ADDENDUM NO. 1

DNR-250004 GREAT COUNCIL OBSERVATION TOWER

1587 US-68,
Xenia, OH 45385

1 SINGLE-LINE DIAGRAM - ELECTRICAL
NTS

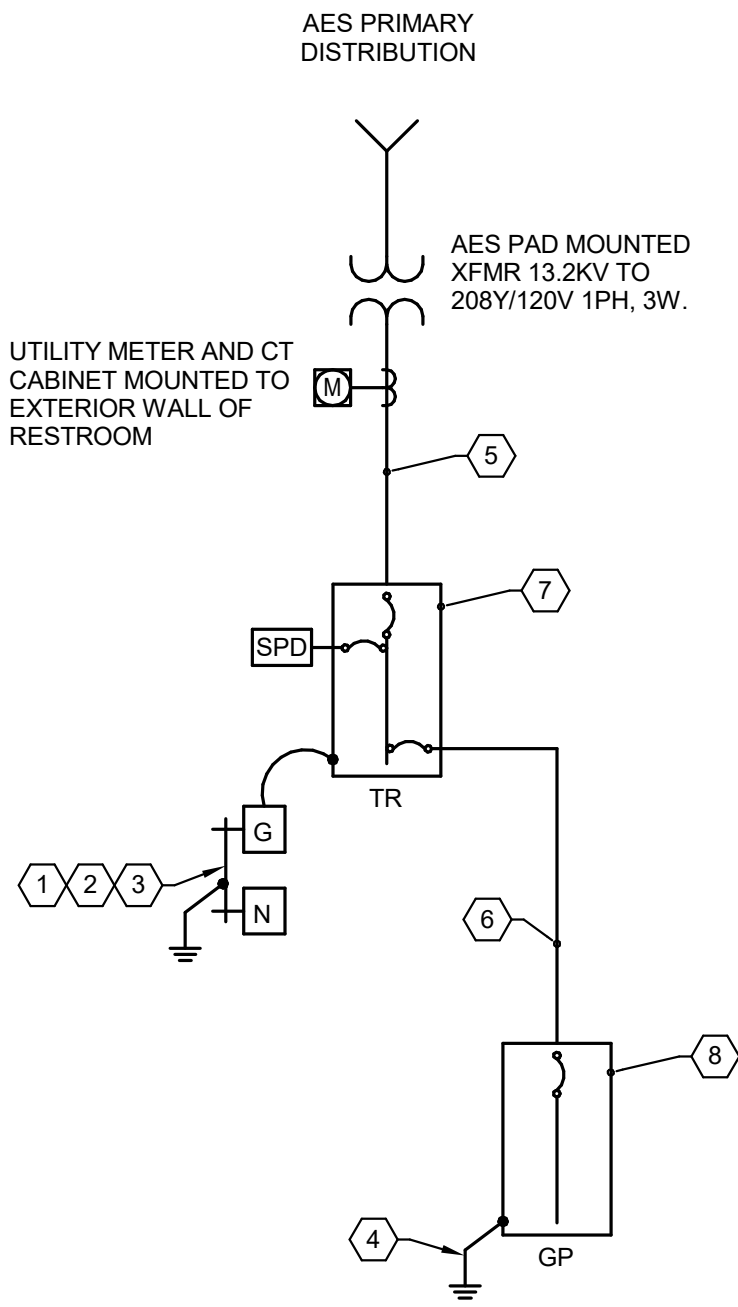
ITEM 25 Q: NOTE 10 ON DRAWING E002 STATES: “PROVIDE 3#600 KCMIL, 4" C FROM PANEL ‘TR’ UNDERGROUND TO NEW UTILITY POLE AND UP POLE TO TRANSFORMERS. PROVIDE 6' EXTRA CONDUCTORS FOR UTILITY COMPANY CONNECTION.” ON THE ONE-LINE DIAGRAM IT SAYS TO PROVIDE TWO (2)

SETS OF 3#250 KCMIL IN 3" CONDUIT FROM PAD TRANSFORMER TO PANEL TR. THESE TWO NOTES APPEAR TO CONFLICT. SHOULD THE ELECTRICAL CONTRACTOR INSTALL A THIRD 4" CONDUIT FROM PANEL "TR" TO THE NEW POLE CONTAINING THE (3) 600 KCMIL CONDUCTORS, AS DESCRIBED IN NOTE 10, OR SHOULD WE FOLLOW THE ONE-LINE AND PROVIDE TWO SETS OF 3#250 KCMIL IN 3" CONDUIT FROM THE PAD TRANSFORMER TO PANEL TR?

ITEM 46 Q: SITE PLAN E002- NOTE 11. PROVIDE 3#3/0, 1#6(G)-2"C FROM PANEL "TR" UNDERGROUND TO PANEL "GP" DIAGRAMS- ELECTRICAL E701- NOTE 6. PROVIDE 3#250KCMIL (AL), 1#2(G)-3"C. FROM PANEL "TR" IN RESTROOM PLUMBING CHASE TO PANEL "GP" IN GARAGE. WHICH ONE ARE WE TO FOLLOW FOR INSTALLATION? OR IS THIS TO OUR DISCRETION?

A: See revised drawings for Addendum 001.

A: See revised drawings for Addendum 01.
